SUBJECT: Initial Drafts of MIL-PRF-26542/1E (1): "MICROPHONE AND MICROPHONE ASSEMBLIES, M26542/1 and M26542/1-01" and MIL-PRF-26542/11B (1) "MICROPHONE AND MICROPHONE ASSEMBLY, M26542/11 and M26542/11-01".
Project numbers 5965-0426-000 and 5965-0427-000

MIL-PRF-26542/1E
w/AMENDMENT 1
DRAFT
SUPERSEDING
MIL-PRF-26542/1E
16 July 2002

**MICROPHONE AND MICROPHONE ASSEMBLIES,
M26542/1, M26542/1-01**

FIGURE 1. Microphone assembly.

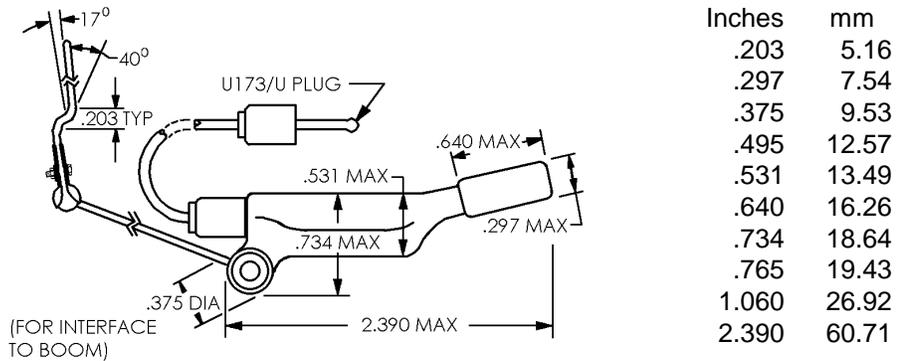
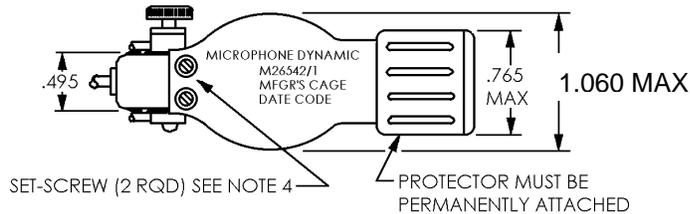
As in the recent initial draft amendment for correction to MIL-PRF-26542/2E, an error was discovered in the top view of figure 1, within the subject documents. During the development of the current revisions, a decision was made to retain the 1.060 MAX dimension for the outer case. An error occurred, resulting in an incorrect "1.000 MAX" dimension appearing in the released document. Coordinated projects have been initiated (5965-0426-000 and 5965-0427-000), to change the outer case dimension to reflect the correct 1.060 MAX value.

The changes include correction of the outer case dimension (1.060 MAX), replacement of the related entry to the metric conversion table on figure 1, and minor editorial updates.
